City of Belmont

1401 Catawba Street Belmont, North Carolina

Re: Review comment letter for SKPR2020.06 Belmont Recreation Center

Sheet No: C200

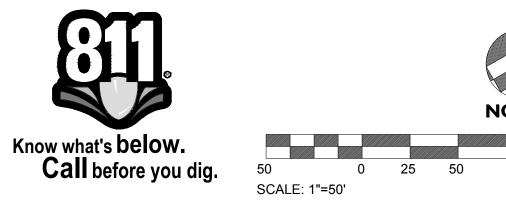
- 1. Consolidate and connect driveways along 13th Street, and make them wide enough for buses and larger vehicles. Add road connections between parking lots for vehicular flow.

- 2. IC-D zoning requires plans to be designed for gathering and ped circulation. Ensure sidewalk connections leading to both entrance locations from main and overflow parking lots and activate any open spaces to promote gathering between buildings.

- 3. Existing water mains, fire hydrants, site lighting, curb and gutter, and tree save/landscaping should be added to site plans.
- 4. Comprehensive Bicycle Plan recommends bike lane along E Catawba Street. Since there are no existing bike lanes adjacent to this site, you may consider requesting deferral of this improvement as part of this project.

- 5. Monument sign location to be indicated on site plans. Obtain sign permit prior to sign installation if installed prior to zoning permit approval.
- 6. Add bicycle parking to site plans and confirm location requirements for ADA parking spaces to ensure proper placement and access are provided.

- 7. Watershed calculations are required. The placement of the building and parking lot does not leave much space for the watershed BMP. The engineer must do the calculations now to formulate the BMP's required.

- 8. A bike and pedestrian crossing of Catawba Street should be included in the planning. This will allow the use of the parking lot as overflow parking for Loftin Park. Design team to coordinate with ESP on exact crossing location, timing, and signalization.

- 9. The City paid about \$70,000 to put the electrical wires underground in the area between the existing and proposed buildings in recent years. It looks like the building is currently proposed on top of the existing lines, which cannot happen as moving the power lines will be extremely expensive. Confirm if remaining above-ground lines can be buried, and/or if any electrical lines are being proposed to be relocated for this project.

- 10. There is not an identified need for a 10' sidewalk along E Catawba St, however commercial sidewalks should be 8' wide minimum per LDC. Evaluate all sidewalk widths and ensure compliance.

- 11. Engineering and Public Works noted that proposed building and parking lot locations should be swapped to allow visibility of the CityWorks facility and not block the building's view of the lake.

- 12. Coordinate with the City and ESP on the future location of Abbey Creek greenway and trailhead and show proposed location on site plans. Parking on site to serve as trailhead parking. Sidewalks that will serve as a part of the trail corridor should be designed at 10-12' in width to accommodate both bike and pedestrian users.

- 13. Existing drainage from the existing CityWorks parking lot discharges directly to the proposed building as currently placed. Proposed BMP needs to be included on site plans prior to submittal of conditional zoning application.

- 14. Fire Hydrant will be needed in the parking lot, and is required to be located within 100' from the FDC. 6" fire line minimum will be required.
